Intersection ID: 10032537	Main Street: N_COLLEGE_ST	Cross Street: N/A	Location:	S
ADA ID: 6E7FF6E97736	Ramp Type: Perp	Initial Pass/Fail: Fail	Overall Compliance: No	Severity Score: 10

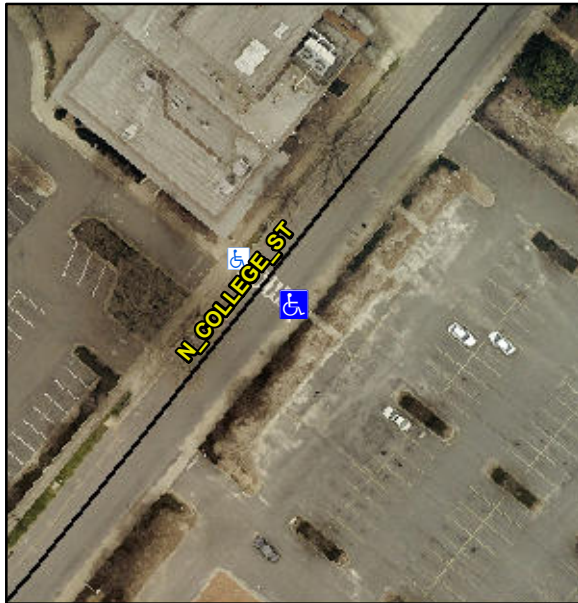
R304.5.1, R304.5.3

Compliance	Description	Data	Compliance	Description	Data
N/A	Ramp Length (in)	100.0	Yes	Ramp Slope (%)	5.9
No	Ramp Width (in)	47.5	No	Ramp XSlope (%)	3.3
N/A	Flare Type LT	N/A	N/A	Flare Type RT	N/A
N/A	Flare Slope LT (%)	N/A	N/A	Flare Slope RT (%)	N/A
N/A	Flare Traversable LT?	N/A	N/A	Flare Traversable RT?	N/A
N/A	Landing Length (in)	N/A	N/A	DWS Provided?	N/A
N/A	Landing Width (in)	N/A	N/A	DWS Contrast?	N/A
N/A	Landing Slope (%)	N/A	N/A	DWS Length (in)	N/A
N/A	Landing X Slope (%)	N/A	N/A	DWS Full Width?	N/A
N/A	Landing Curb? (Y/N)	N/A	N/A	DWS Offset (in)	N/A
N/A	Shared Landing?	N/A			
N/A	Gutter Ponding?	N/A	N/A	Gutter Slope (%)	N/A
N/A	Gutter Lip Ht (in)	N/A	N/A	Gutter X Slope (%)	N/A
N/A	Painted X Walk1?	Yes	N/A	Painted X Walk2?	N/A
	X Walk 1 Direction	To NW		X Walk 2 Direction	N/A
N/A	X Walk 1 Width (in)	113.0	N/A	X Walk 2 Width (in)	N/A
	X Walk 1 Slope (%)	6.4		X Walk 2 Slope (%)	N/A
	X Walk 1 X Slope (%)	1.6		X Walk 2 X Slope (%)	N/A

N/A	Ramp inside XWalk1?	Yes	N/A	Ramp inside XWalk2?	N/A
	Road Slope (%)	N/A	N/A	Clear Space?	N/A
	Road X Slope (%)	N/A	N/A	Clear Space to XWalk (in)	N/A
N/A	Any Obstructions?	N/A	N/A	Storm Grate/Utility Hazard?	N/A
	Obstruction Type			Storm Grate/Utility Type	
		N/A			N/A
			Yes	Surface Condition? (G/P)	Good

Remove & Replace Entire Ramp.
